UNITED STATES PATENT AND TRADEMARK OFFICE

APPLICATION NO.	FILING DATE	FIRST NAMED INVENTOR	ATTORNEY DOCKET NO.	CONFIRMATION NO.
10/659,633	09/10/2003	Gary Shapiro	JJH-03-151-GS	5200

Office Action Summary

DETAILED ACTION

FIG. 1.

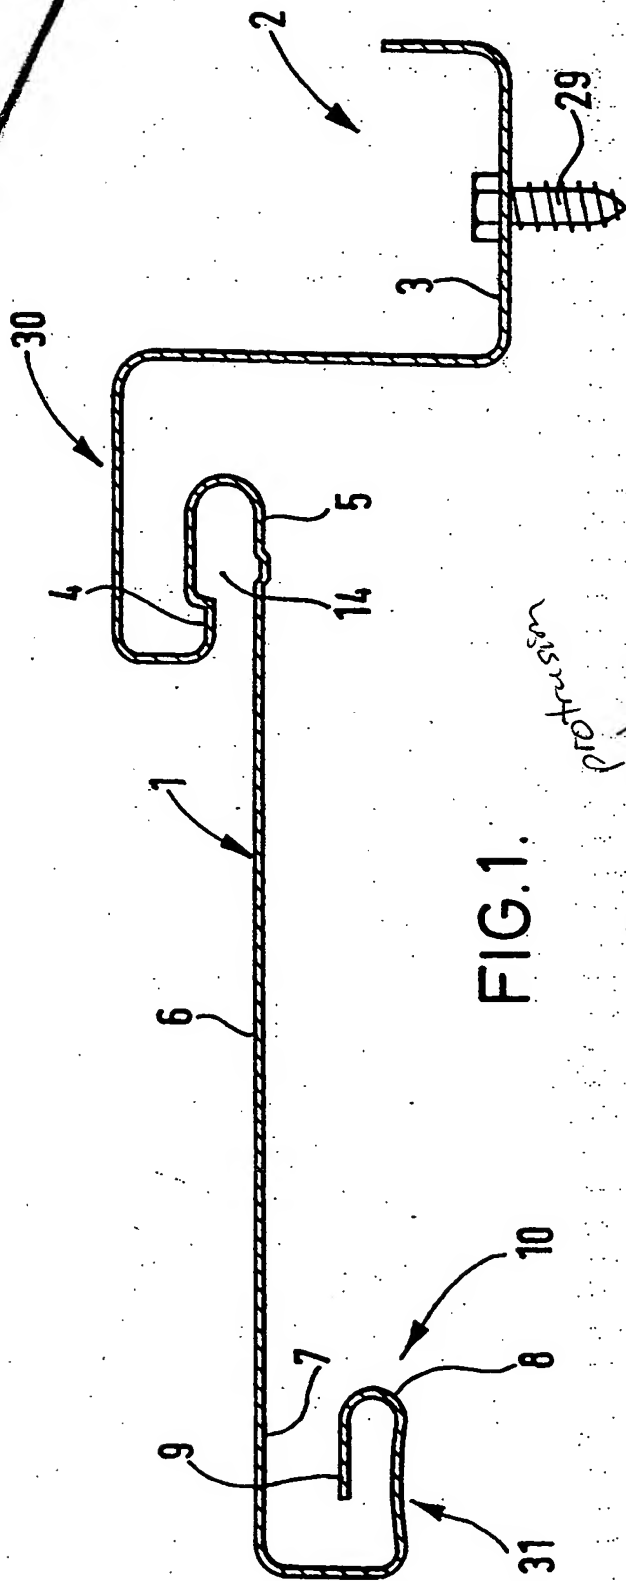
In regard claim 3, Bullen teaches the claimed invention as stated (see claim 2 above) and further including holes for fasteners 29 inserted and each said flange extending for a minimum width from said side edge of said panel a distance at least wide as the diameter of the head of a screw (see figure 1). And Bullen further teaches the male extension having on its surface one or more protrusions and corresponding convex indentation (where 31 points to). However, Bullen does not teach specifically there are more than one corresponding indentations (more than one) on the male extension surface. Tamura teaches an elongated panel having male extension or flange 20 and having more than one indentations on its surface (see figure 1). At the time of the invention, it would have been obvious to one having an ordinary skill in the art to modify Bullen's roofing panel to have more than one indentations as taught by Tamura. The motivation for doing so would have been to enhance more integrity and better engagement between panels.
